ONE 90 (PREVIOUSLY WATERS TECHNOLOGY PARK )  
PA 18-013 MODIFICATION SUBMITTAL :  
ISSUE DATE: 10-13-20

PA MODIFICATION - INTENT AND DESCRIPTION:  
To review and approve architectural building related design modifications made during plan check for code compliance and constructibility.

PA MODIFICATION COBALT- BLOCKS REVISIONS SUMMARY

PA MODIFICATION - INDIGO ROWS REVISIONS SUMMARY

SECOND LEVEL PLAN

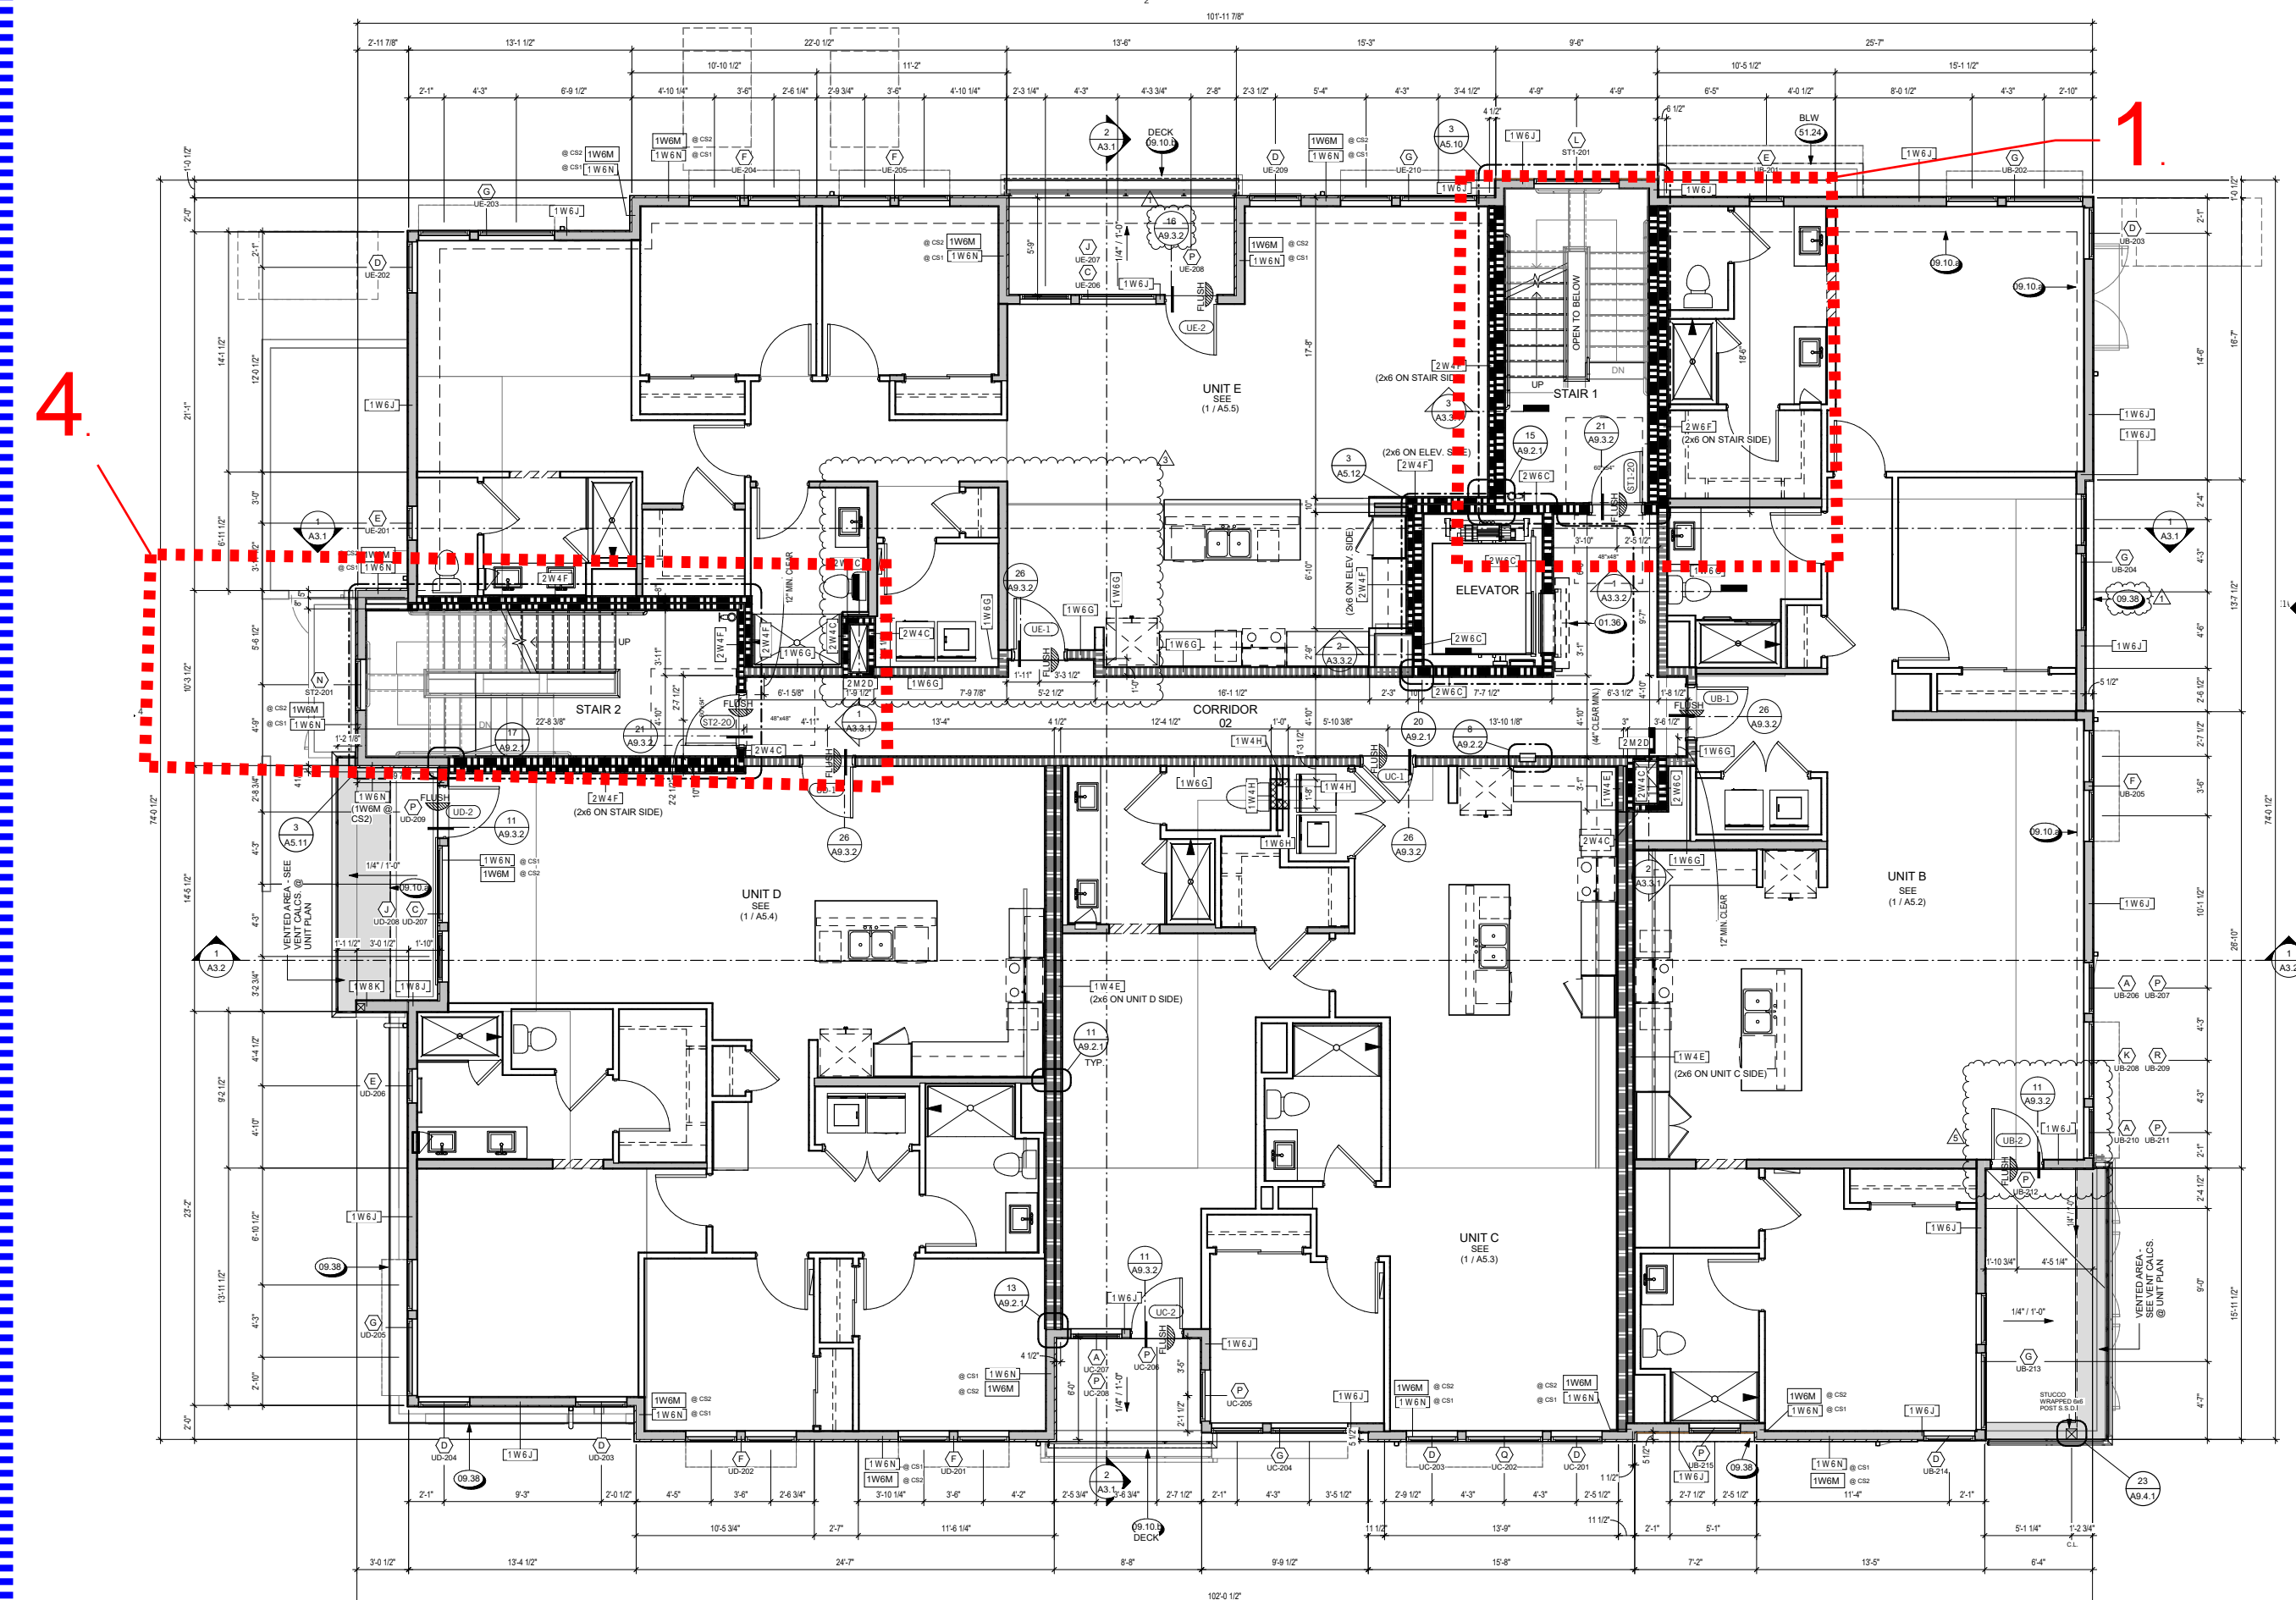
1. First floor common hallway and upper floor hallways were reconfigured to include second exit stair and enclose the lobby exit stair per building code requirements since the building was not code compliant in the previous planning application
2. Fire utility closets were added within current footprint which were missing in the original planning application
3. Electrical utility closets were extended within current footprint.
4. Added second enclosed exit stair as required by building code. This required minor change to the building footprint and exterior wall elevation.
5. Removed non compliant exit hallway. Garages were reconfigured to accommodate van accessible parking in each building per plan check requirements.
